M249  
Machine  
Gun...

# Sling Swivel Adapters Part II

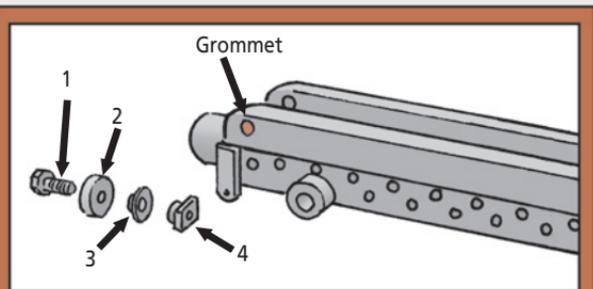
**NOW THE CHANGE:  
THE PROCEDURE FOR  
INSTALLING THE SLING  
WHEN THE RECEIVER IS  
MISSING THE GROMMET  
ASSEMBLY HAS BEEN  
REVISED...**

1. Place the lug (1) into the thick spacer (2).
2. Use the spacer (3), along with the thick spacer (2), to replace a missing grommet.
3. Place and hold the stud (4), lip end first, in the inside of the receiver and into the spacer (3). The spacer can be on either the inside or outside of the receiver.
4. Add one drop of Locktite, NSN 8030-01-499-3589, to the threads of the lug (1). Screw the lug with spacer (3) into the stud (4) and snug down the lug.
